PCN-20210216a TE0712-02 DDR3, Flash Change and Product Update (Revised)

Company	Trenz Electronic GmbH
PCN Number	PCN-20210216a
Title	TE0712-02 DDR3, Flash Change and Product Update
Subject	BOM change
Issue Date	(2021-02-17), Revised 2021-03-09

This change affects all Trenz Electronic TE0712 SoMs of revision 02: TE0712-02-*

#2 Replaced Flash (U4) to IS25LP512M-RHLE All SoMs use S25FL256SAGBHI20 Flash (U4)

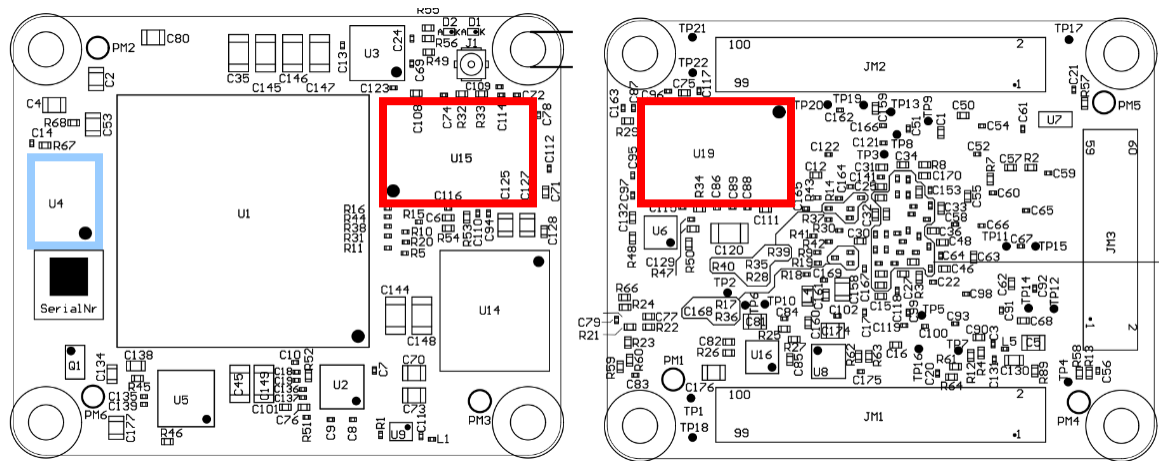
Type: BOM change
Reason: Ensure long time availability.
Impact: ~~Jedec Manufacturer ID changed from 01h to 9Dh, the device ID from 18h to 19h. 512Mbit flash are now available.~~

Type: BOM change
Reason: The planned IS25LP512M-RHLE is listed as 'Supported Flash Memory Devices for Artix-7 Device Configuration' in Xilinx UG908 (since version 2019.1), but there are unsolved problems with reboot after petalinux was started. Therefore this change is canceled. Only modules where other than S25FL256SAGBHI20 was used are changed to S25FL256SAGBHI20.
Impact: Jedec Manufacturer ID is 01h, the device ID 0219h. Size does not change, 256 Mbit flash are available.

Locate DDR3 RAM (U15 top, U19 bottom) and Flash (U4 top) on PCB:

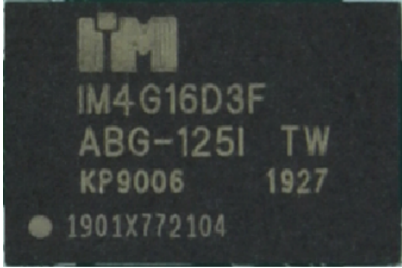
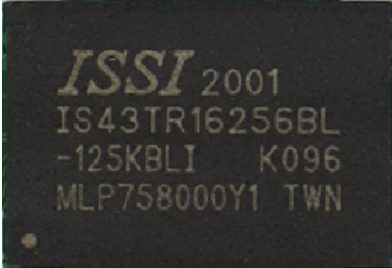
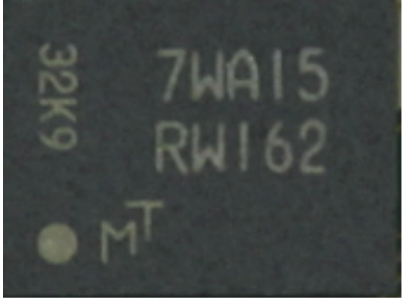
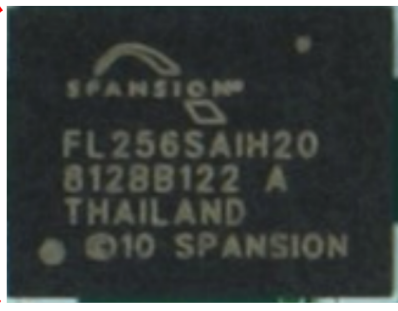
#1 Change DDR3 RAM (U15, U19) from IM4G16D3FABG-125I to IS43TR16256BL-125KBLI

#3 Clock Revision Change (U9) SiT8008AI-73-XXS-25.000000E to SiT8008BI-73-XXS-25.000000E

old	new
-----	-----

IM4G16D3FABG-125I	IS43TR16256BL-125KBLI

S25FL256SAGBH120 or MT25QL256ABA8E12-1SIT	IS25LP512M-RHLE
 TE0712-02-2CA and TE0712-02-72C03-M only:
